Missouri Center for Oral Surgery & Implants at Wentzville

Wentzville, St. Charles County, Missouri

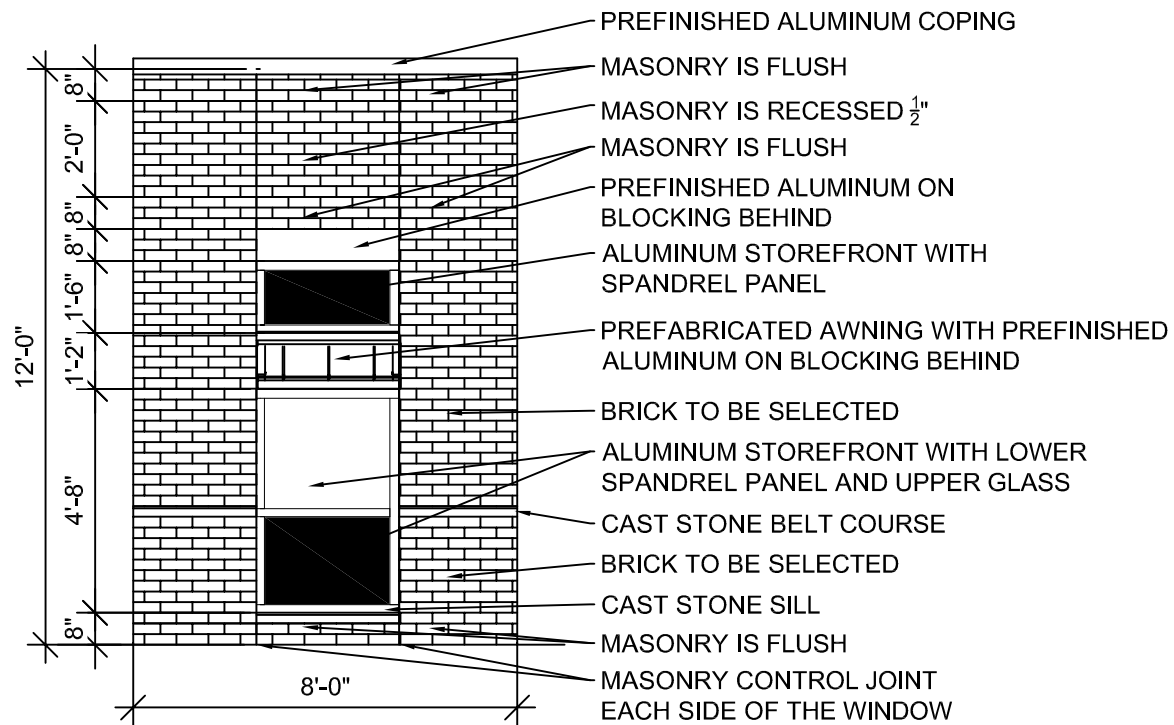
14. Question: Sheet C500 keyed note 9 calls for a site proof fence. Need to know height and type of fence required as the details on C900 for the retaining wall are not sight proof.

Answer: The length of fence that is running from the building to the retaining wall is to be 6' tall sight proof vinyl fencing. Product to be used can be Bufftech with smooth woodgrain or equal.
